# County of Fairfax, Virginia

## STAFF REPORT

APPLICATION PCA B-993/FDPA B-993-02 and  
Resource Protection Area (RPA) Encroachment Request #84-96-WRPA-001-1

PROFFERED CONDITION AMENDMENT/FINAL DEVELOPMENT PLAN AMENDMENT  
 PCA/FDPA PLAN  
**CIRCLE TOWERS APARTMENTS**  
 PROVIDENCE DISTRICT  
 FAIRFAX COUNTY, VIRGINIA

DESIGNED BY: PLR	DATE: 11-11-11
DRAFTED BY: CAD	DATE: 7-7-11
CHECKED BY: PLR	DATE: JUNE 2009
SCALE: HORIZ. 1" = 40'	VERT. 1" = 40'
SHEET 2 OF 33	
DD. NO.	CAD NAME: CB08SPCA
LAYOUT: PCA	FILE NO. 08085.01-00

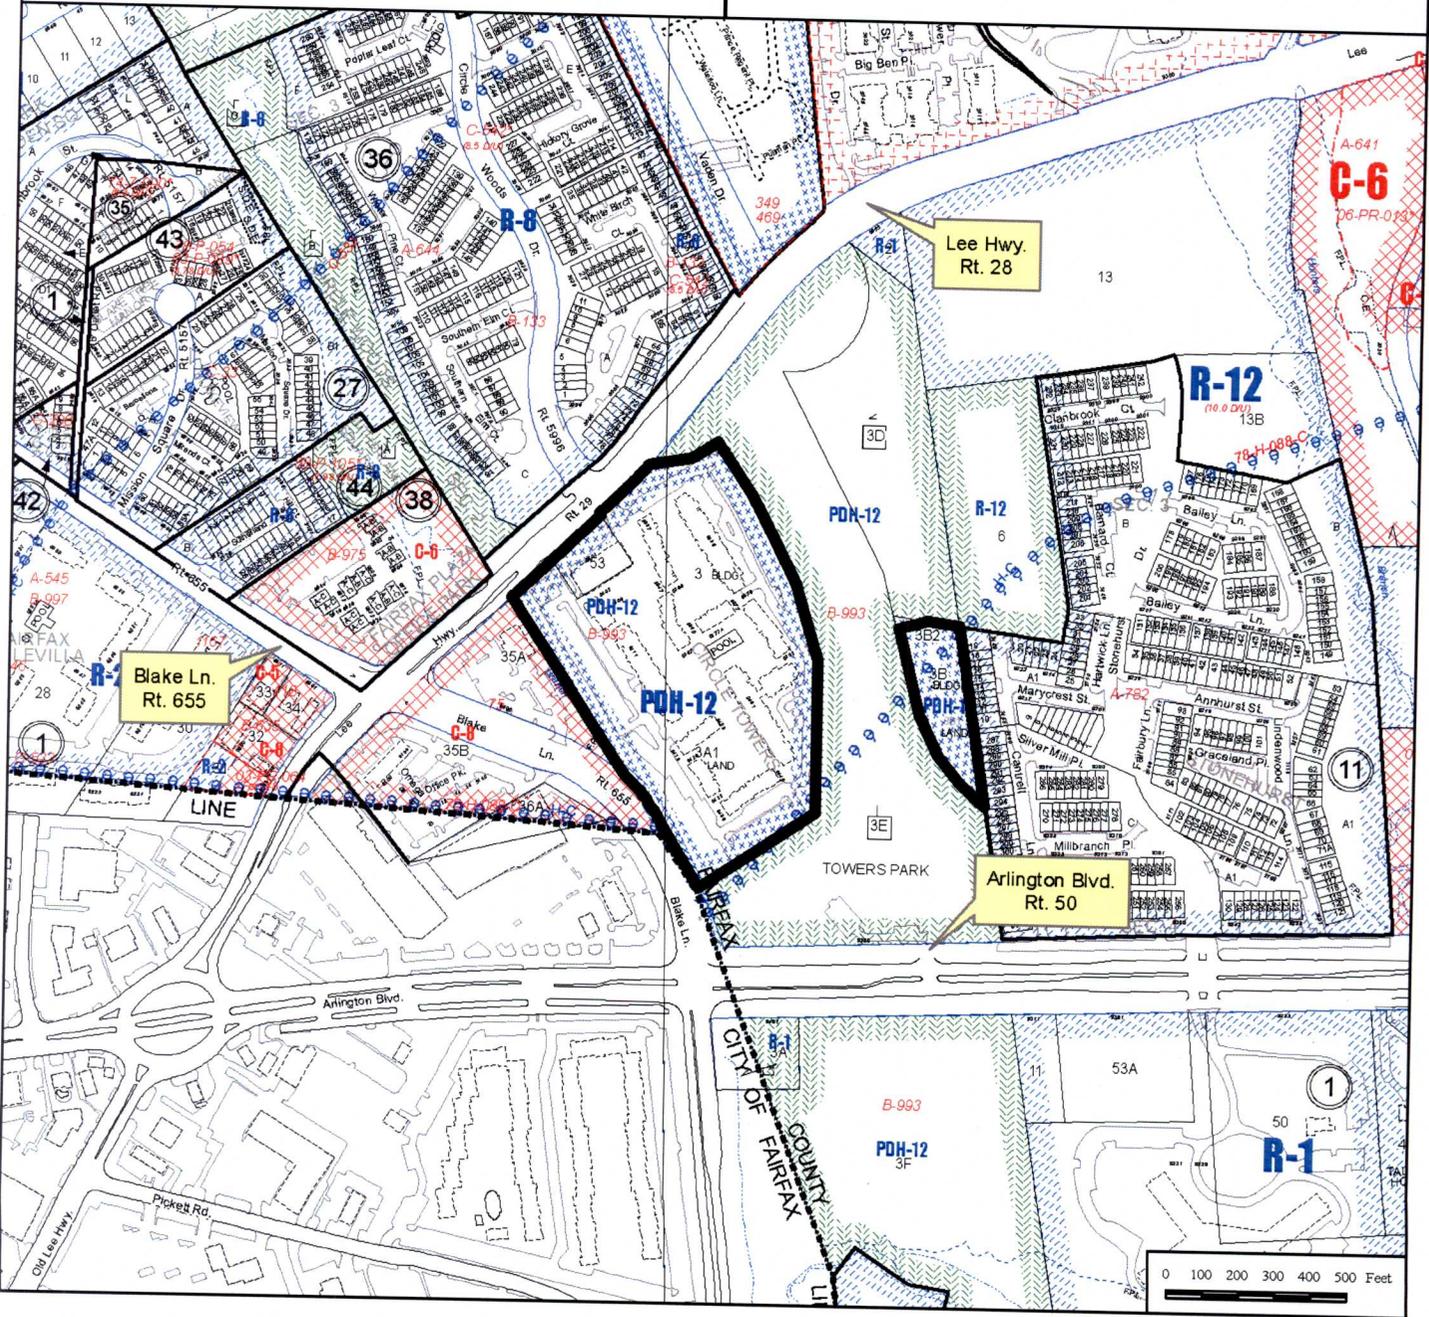
Draft Proffer 36 addresses the applicant's commitment to construct a trail connection to the existing bus stop located along the north side of Route 50. This trail connection is only reflected on Sheet 2 of the plan graphic at a scale of 1" = 200' but appears to be proposed across Park Authority property. The Park Authority has previously requested additional information to evaluate this request including topography and preliminary grading. No additional information has been provided. Without sufficient plan level detail, the Park Authority cannot evaluate the impacts to parkland and, therefore, cannot support the request at this time.

PROPOSED CONDITION AMENDMENT/FINAL DEVELOPMENT PLAN AMENDMENT  
 TREE PRESERVATION PLAN  
**CIRCLE TOWERS APARTMENTS**  
 PROVIDENCE CONTRACTORS  
 FAIRFAX COUNTY, VIRGINIA

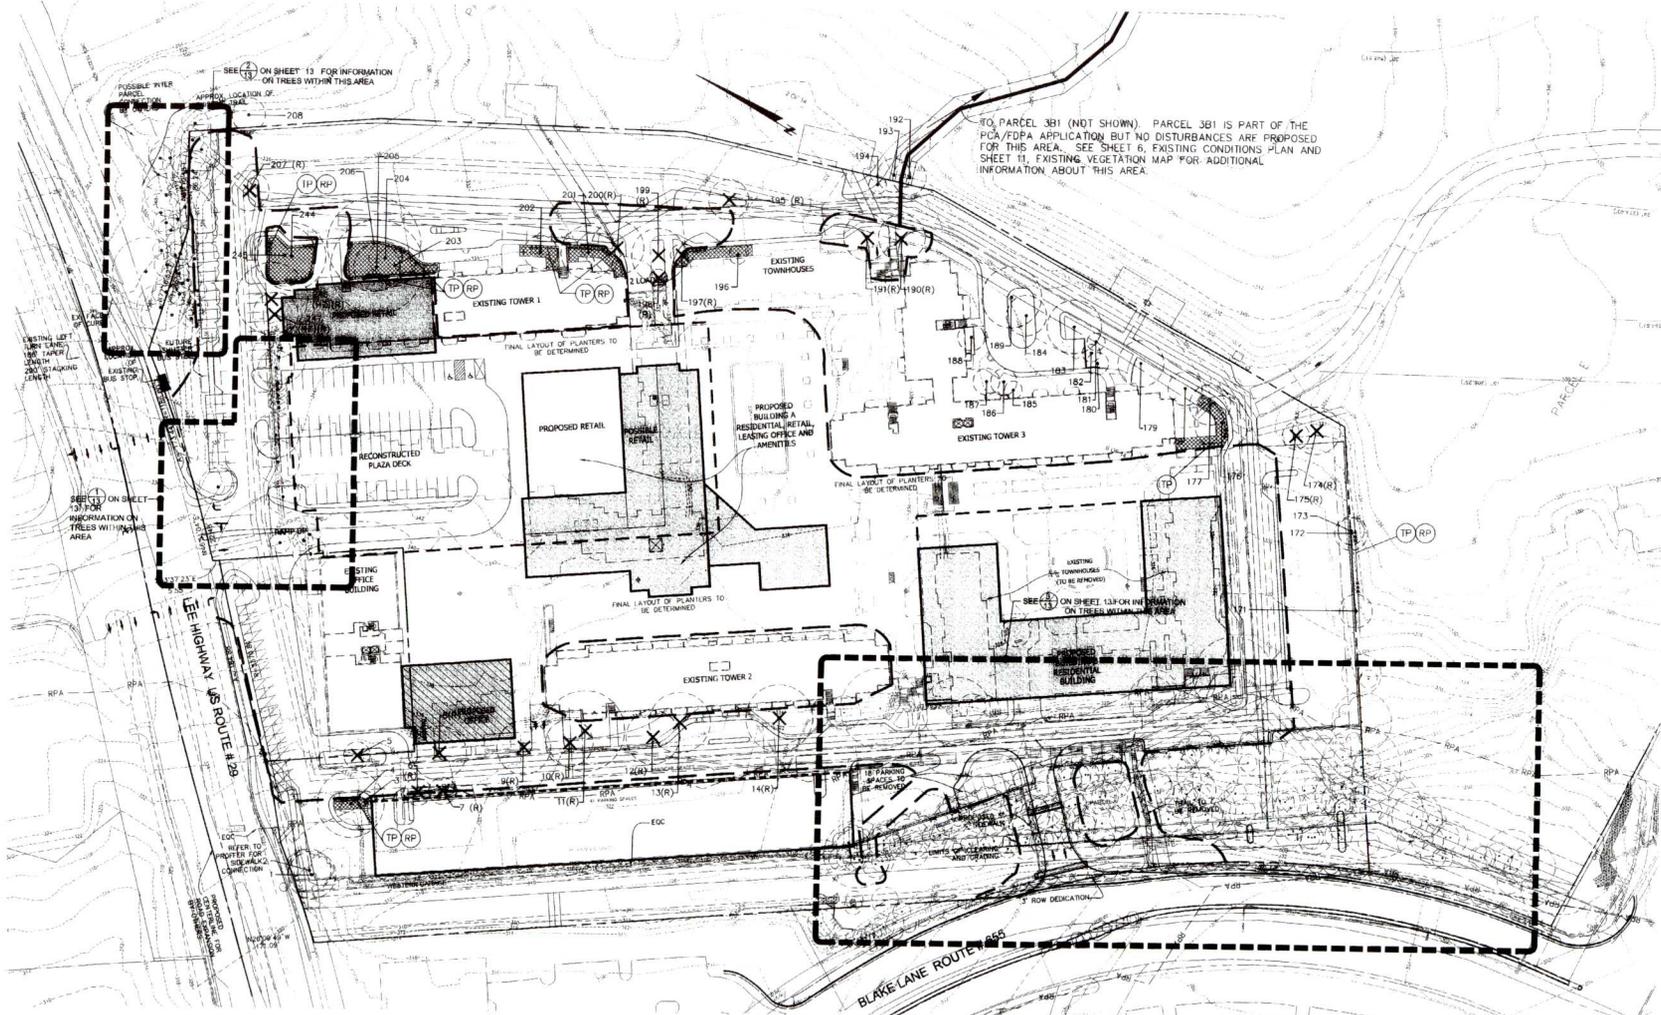
Several plan sheets indicate any area at the northeast corner of the property which is identified on Sheet 12 of 33 as “Possible Inter-Parcel Connection by Others”. The location of this connection is reflected on Park Authority and in an area where the existing grade, approximately a 22% slope, is not favorable for construction. A connection in this location would require extensive grading with significant disturbance to parkland. The limits of clearing and grading do not reflect construction in this area, nor does the tree preservation plan. No information is provided to evaluate any inter-parcel connection; therefore, the Park Authority cannot support any potential connection in this area.
